City of Griffin 100 S. Hill St. Griffin GA 30223

Re: Final Engineering Inspection Report Project Number 21-0420
Existing Precast Concrete Parking Structure Next to City Hall
List of tasks that were not included in IMMEC's scope that still need to be addressed

Photo 2A Aluminum Handrail and Spalling Concrete

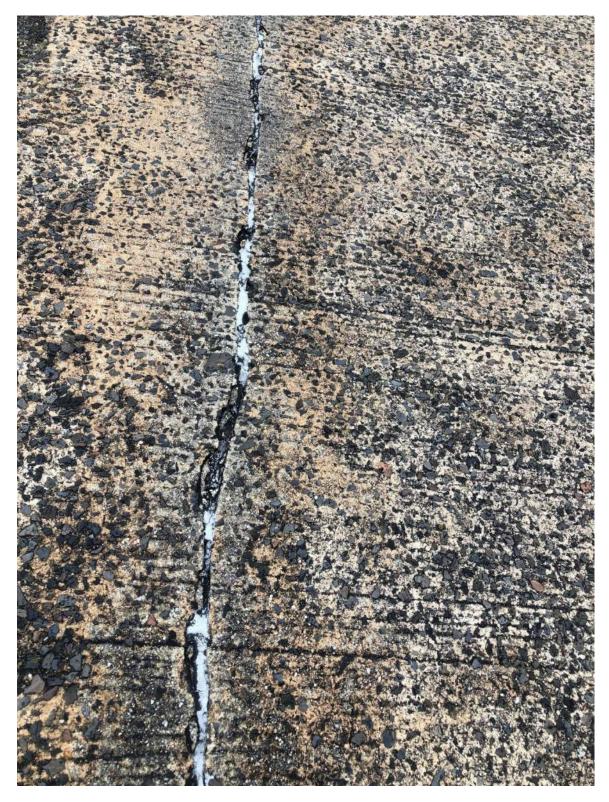
- 2. The existing aluminum handrail at the center of the parking deck at the ramps is cracked and loose. They will not hold the required pedestrian load per the building codes. The handrails can be welded back together and reattached to the existing columns.

Photo 4 Top Concrete that need to be sealed

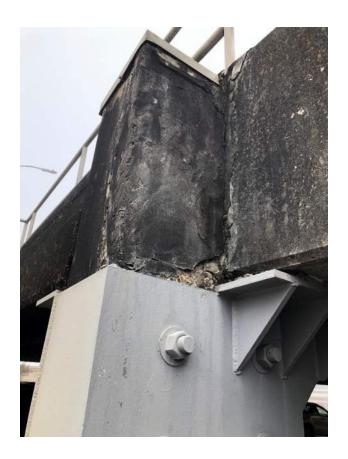
- 4. The exposed concrete at the top of the parking deck needs to be sealed/painted. This includes the tops of the columns and beams and the deck exposed to the weather.
